Job address: 27 NE COOK STREET

Description of workFIRE REPAIR TO REPLACE MAIN ROOF
STRUCTURE AND REAR DECK, AND REPAIR
REAR WALL.

STRUCTURAL CHECKSHEET

Application # 17-126902-000-00-RS

REFERENCE NUMBER: 4.0

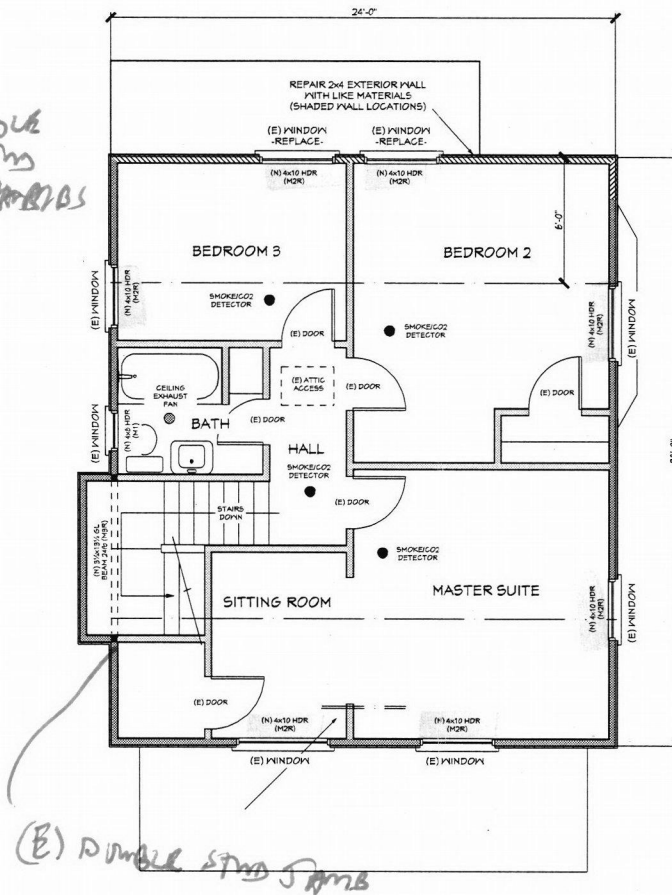
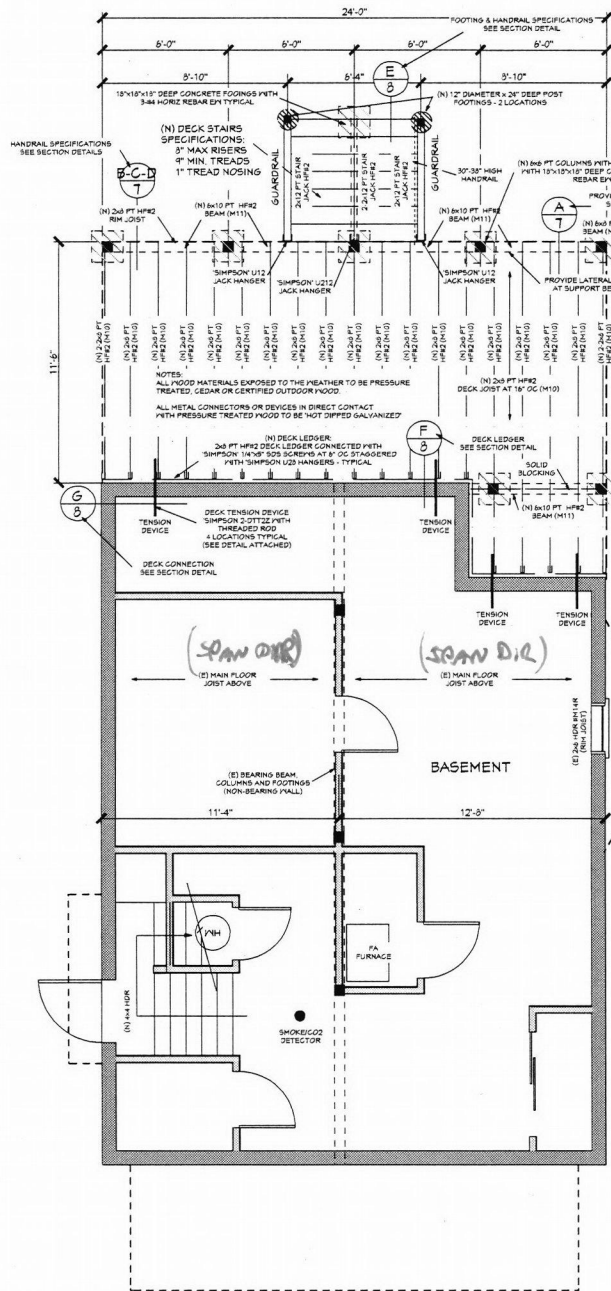
- 1) Member 2: It appears there is a longer span at Bedroom 2 that may control the design of member 2. Please double check the calcs and verify a 4x8 is adequate.

- 2) Member 3: It does not appear that all of the roof truss loads that are supported by member 3 are shown in the calcs. Please clarify that all A02 and A03 truss seat loads are shown or are incorporated into the uniform load. Increase the beam size if required. Please clarify if jambs are needed and that they are shown on the drawings (with a load path to the foundation).

- 3) Member 4: Please clarify if the uniform load on member 4 includes the roof loads from the trusses above in addition to the wall self-weights and the 2nd floor loading.

- 4) Member 5: Please see the comment on member 4 for beam loading clarification.
- 5) Member 7: Please clarify if the loading provided accounts for all the roof trusses as well as the second floor. A02, A03, and JAS02 appear to load this member in addition to floor joists and wall loads. Please clarify what loadings H and I represent. Clarify if jambs are needed and that they are shown on the drawings.

- 6) Member 8: Please confirm the uniform load on this member includes wall dead load and roof load from areas such as JA04 and J503. Also clarify the jambs.

Please see my revised calculation and pages 4/5 attached per your comments below, with an additional calc for the basement headers. Please let me know if you have any questions.

REFERENCE NUMBER: **5.0**

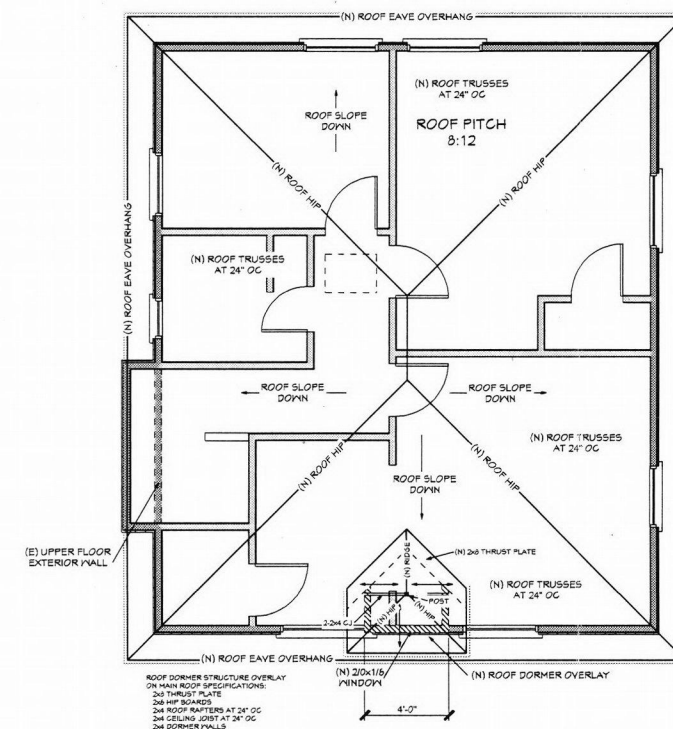
- 8) A) On sheet S4.0, please make sure jambs for new headers are indicated and carry load to the existing basement concrete wall. B) Please clarify the actual span of the floor joists so walls perpendicular to the joist spans can be identified. The void drawing 5.0 was used to confirm joist loading type for beam calc review. C) Any existing or new header/lintels in the basement walls should be justified for the new roof loading. These may be shown on S5.0

<p>on revised sheet 8. Also see the revised structural calculations as stair jack calculations have been added for your reference.</p> <p>C. See page 6 of the submitted plans for the cross section notes and specification indicating that 7/16" structural sheathing will be used at the repair areas of the exterior walls. Also see the nail and attachment schedule on page 9 of the submitted plans for the approved attachment and spacing method of the exterior structural wall sheathing.</p> <p>Also see page 9 of the submitted plans and the cross section notes and specifications as it mentions the interior wall construction and specifications.</p>	
	<p>A. See the revised plan sheets as the restoration has been revised to include roof trusses at the main roof structure and rear roof structure areas. See the engineer stamped roof truss detail attached to accommodate this change.</p> <p>B. See the revised plan sheets as the headers for the exterior wall openings have been specified as new, and the structural calculations for these headers have been included in the new structural packet.</p> <p>C., D., E., F., H. <i>The roof structure has been revised to roof trusses.</i></p> <p>G. The front 4' wide dormer is a "overlay" on the main roof structure below. See revised page 5.0.</p>	2.
